State Water Resources Control Board

Division of Drinking Water

2017 SANITARY SURVEY FINDINGS Palo Alto Park Mutual Water Company, Water System No. 4110020

Figure 4. Well 2 - Opening beneath building structure.

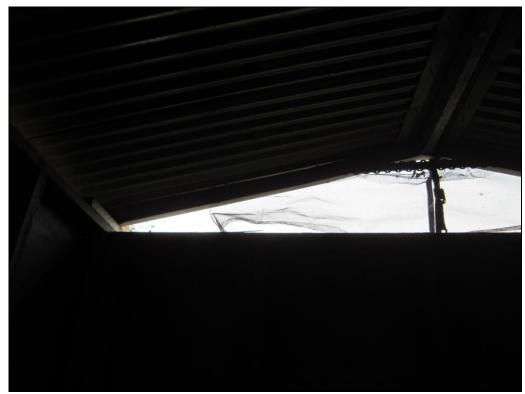
Groundwater supply wells should be well protect against rodents or other animals. The building structure around Well 02 have separated from the concrete slab, creating an opening at the base of the building (figure 4). The screens on several of the building structures have come loose or fallen off (figure 5). Please secure the buildings to prevent animals from gaining access to the well site.
